**Seattle  
Public  
Utilities**

# **Options Analysis Engagement Findings**

**17th Ave NW Stormwater Improvements**

# Respondent Sentiment: Project Option 1

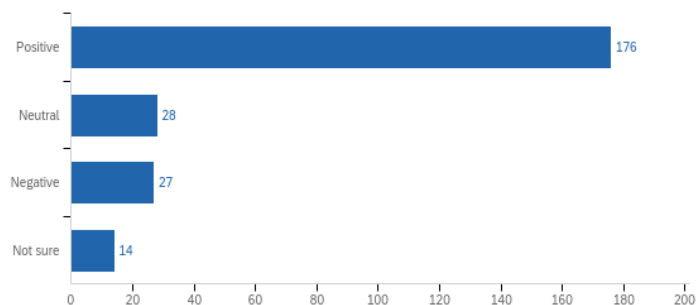
In general, survey respondents had a positive impression of Option 1. 70% of participants viewed this option positively, whereas 10% viewed this option negatively.

When asked which features of Option 1 should be included in the final concept, there was clear consensus for more green spaces, trees and natural drainage, and a sidewalk as depicted in this option.

A few respondents noted that any added trees should not encroach on driveway access and that this change may impact how garbage and recycling bins are picked up along the street.

The sidewalk was especially viewed as favorable due to the volume of school-aged street users traveling to and from Whitman Middle School. However, some respondents indicated that the narrow width of the added sidewalk might feel cramped especially during busy times or for wheelchair or walker users.

When asked which features of Option 1 sparked concerns, the overwhelming majority of respondents were concerned about the loss of parking. Respondents largely noted that parking availability has been a historical issue in the area and that it has become worse in recent years with the construction of new

Many respondents indicated that homes in this area do not feature adequate driveway space, or do not have garage options, so cars must be parked on the street. There were also concerns amongst those in the area with disabilities, who need to be able to park close to their homes.

Some respondents noted that the tension of excitement about adding trees and sidewalks at the expense of reducing parking may present challenges in the future. This stretch of 17th Ave NW has been designated as a Healthy Street by SDOT. There were concerns noted about cars maneuvering in a narrower street without hitting bikers, runners, or other pedestrians using the space. Some respondents expressed a desire for additional traffic calming features to help improve pedestrian safety, including speed bumps and curb bulbs.

## Respondent Sentiment: Project Option 2

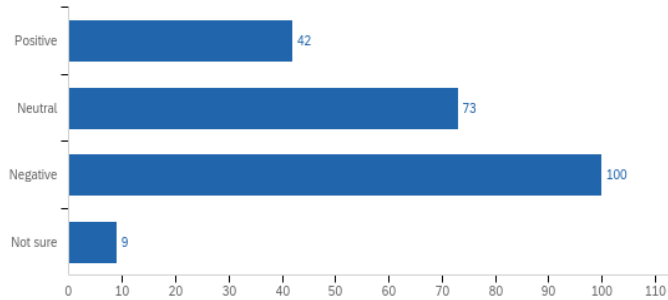
In general, survey respondents had a negative to neutral impression of Option 2. 40% of respondents had a negative response and 29% had a neutral response, whereas only 17% of respondents had a positive impression of Option 2.

When asked which features of Option 2 should be included in the final concept, many respondents indicated that the natural drainage and sidewalks depicted in this option were favorable, as was the case with Option 1. Overall, respondents were excited about the prospects of these two street improvements regardless of the design option.

However, nearly all respondents felt that Option 2 was an “incomplete” street project by leaving the east side unimproved and for future development. Several participants expressed concern that both options presented reduce parking by the same amount (50%), but Option 2 leaves open the possibility of losing more parking in the future as the east side of the street is developed. Respondents were generally unhappy about the parking reductions in both options, but the ambiguity of Option 2 was less favorable than the fully designed street in Option 1.

Many participants believed that leaving the gravel section of 17th Ave NW would still allow for diagonal parking, which would present parking confusion and safety issues given the Healthy Street designation and more people using the street for walking or recreating. Overall, most participants preferred Option 1’s planned parking scheme over the additional flexibility of the gravel section in Option 2. The width of the street after improvements also brought up safety concerns for bicyclists using the Healthy Street and for school-aged users walking the path to NW 90th St.

Respondents also expressed dissatisfaction at the lack of trees in Option 2. The inclusion of trees along 17th Ave NW was widely considered a major project benefit in addition to the planned natural drainage systems. Some respondents indicated that all other benefits and impacts held constant, they would prefer an option with guaranteed street trees instead of relying on future development to add them.

### NW 87th St

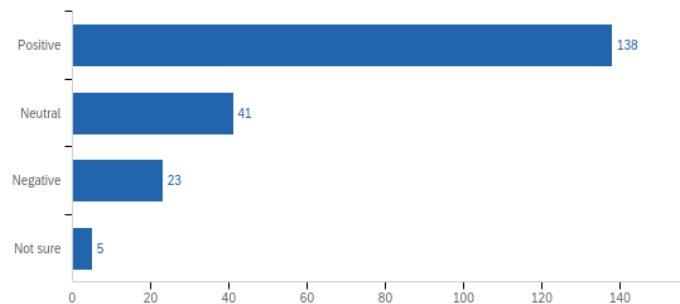
In general, survey respondents had a positive impression of the proposed improvements on NW 87th St and NW 90th St. 55% of participants viewed this work positively, whereas 9% viewed this option negatively. Many respondents were neutral about these proposed improvements (16%).

Respondents generally appreciated the sidewalk and the addition of natural drainage elements. The natural drainage installations along NW 87th St were viewed as overwhelmingly popular due to longstanding drainage issues near NW 87th St and 17th Ave NW.

The curb bulb addition at NW 90th St was also viewed positively due to its ability to reduce speeding and improve pedestrian safety through this popular walkway.

Some respondents expressed concern that any plantings at this curb bulb might limit visibility near the crosswalk. Other respondents suggested raising this crosswalk or adding flashing lights to create additional traffic calming.

The reduction in parking along these stretches of the street were not viewed favorably. Respondents brought up that a lack of parking along NW 87th St and NW 90th St might spur drivers to park their cars in other parts of the neighborhood, thus extending the parking availability issue to the broader community. Some respondents felt that additional traffic calming measures could be helpful for deterring through traffic, especially on NW 87th St. Many respondents mentioned that the neighborhood is often used by drivers avoiding the light at 15th Ave NW and NW 85th St, just southeast of the project area, which has become a bottleneck due to an ongoing increase in neighborhood density.

- **By adding sidewalks to the north side of NW 87th, will there be enough room for two cars to pass safely with cars already parked along that stretch of street? There are hazards now with people parking too close to the roundabout.** Yes, cars will still be able to pass each other in the two 11' travel lanes on NW 87th St. The narrowed roadway on 17th Ave NW will require one car to yield to the other car passing by, as is typical for "Neighborhood Yield" streets throughout Seattle neighborhoods.
